UNITED STATES PATENT AND TRADEMARK OFFICE

APPLICATION NO.	FILING DATE	FIRST NAMED INVENTOR	ATTORNEY DOCKET NO.	CONFIRMATION NO.
10/697,225	10/30/2003	Mary Elizabeth Davis	9396	9781

Office Action Summary

DETAILED ACTION

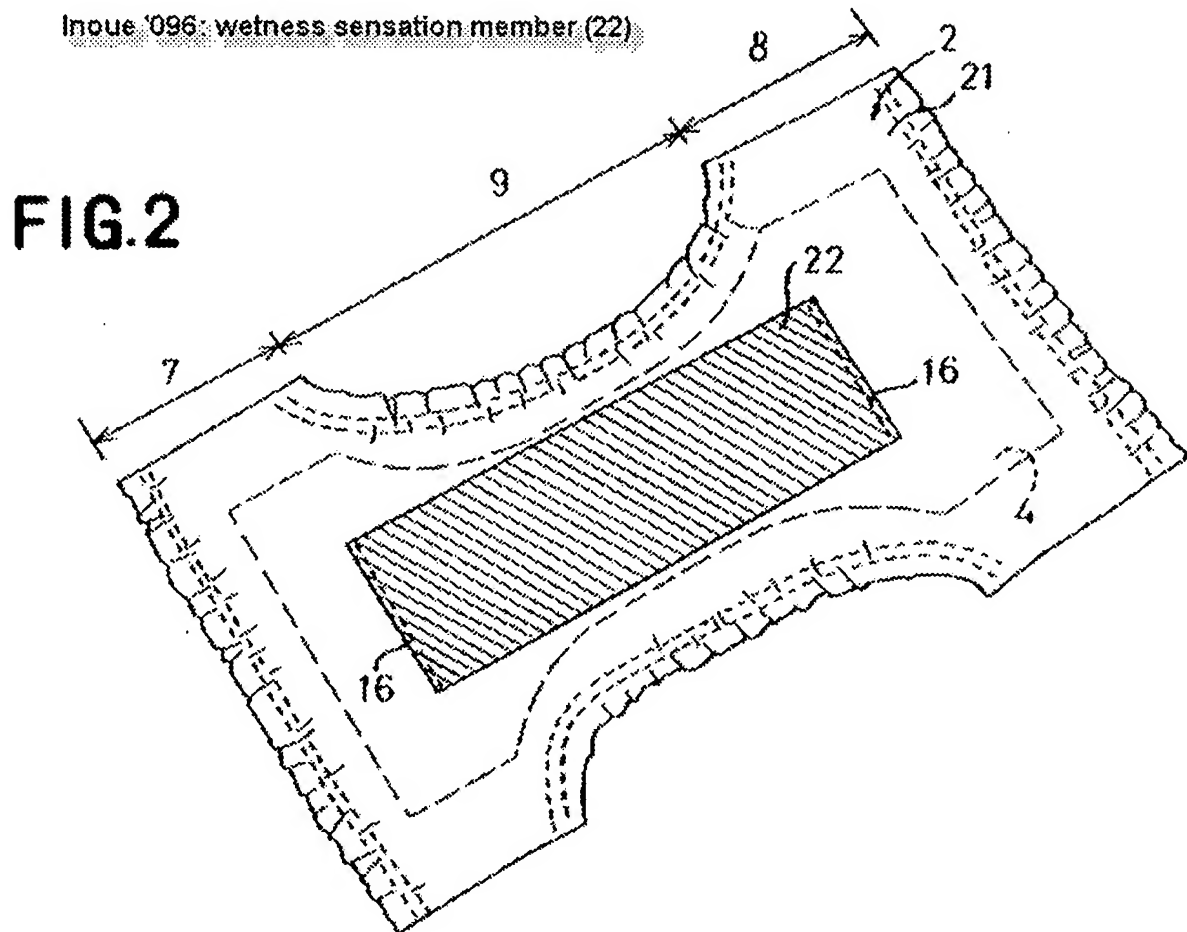
As seen in Figures 2 and 3, Inoue teaches a toilet training diaper comprising a wetness sensation member (22) integrated with the topsheet (2). As best depicted in Figures 2 and 3, for purposes of illustration Figure 2 is reproduced below, because the wetness sensation member is a smaller piece of material located on top of the flow control layer (21) and further comprises a different material having different properties and characteristics (c. 2, ll. 30-67 to c. 3, ll. 1-10), the examiner has a reasonable basis to conclude that the wetness sensation member (22) would

differ in appearance and therefore would be noticeable from its surroundings, *e.g.*, by differing in coloration, hue, or tint, by differing in lightness, darkness, or contrast, by differing due to the presence or absence of solid color forms, or by any other variation serving to create noticeable visible differentiation, and would be substantially unchanged upon wetting. Additionally, Inoue teaches at c. 3, ll. 58-59 that there is a level difference between the layers, i.e. the wetness sensation member layer (22) is raised or in relief above the flow control layer (21).

Thus the wetness sensation layer of Inoue meets the definition of visible highlighting as set forth by Applicants and therefore fulfills the claim limitations. Therefore, it would have been obvious to one having ordinary skill in the art at the time the invention was made to form the wetness sensation member of Iguae visibly highlighted as taught by Inoue in order to provide a noticeable wetness sensation member for toilet training since it has been held to be within the general skill of a worker in the art to select a known material on the basis of its suitability, here, appearance, as a matter of obvious design choice. *In re Leshin*, 125 USPQ 416.
